MEMORANDUM

TO: District of Columbia Zoning Commission

DATE: July 14, 2021

SUBJECT: ZC 17-08A, Modification of Significance, Square 5194, Lot 827 (formerly Lot 824) Providence Place

Figure 1: Potential On-Street Loading Areas for Trucks taller than 12'-6"
ZC 17-08A EXHIBIT 3F – PROPOSED LOADING AREA

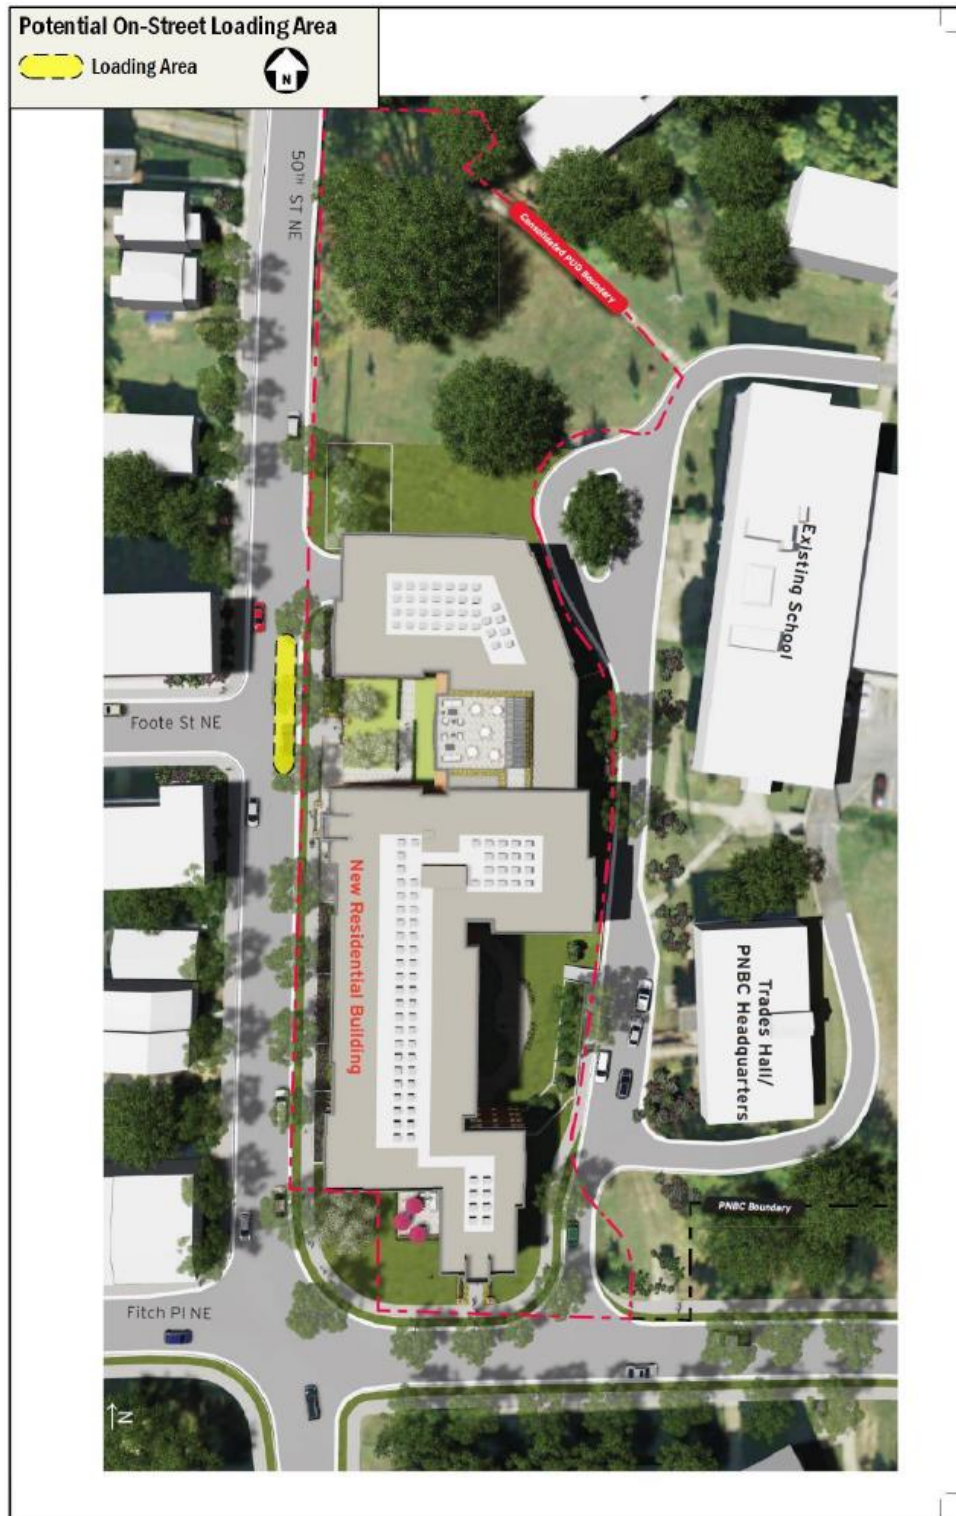
Exhibit 3F provides the applicant’s loading management plan, which would include clearance height signage for trucks taller than 12 feet 6 inches, as well as management and scheduling of deliveries for move ins/outs with larger trucks. The applicant also proposes loading for trucks taller than 12 feet within public space. OP would coordinate between the applicant and the District Department of Transportation to confirm the feasibility of on-street loading for larger trucks shown in the applicant’s plan (attached) prior to the public hearing.
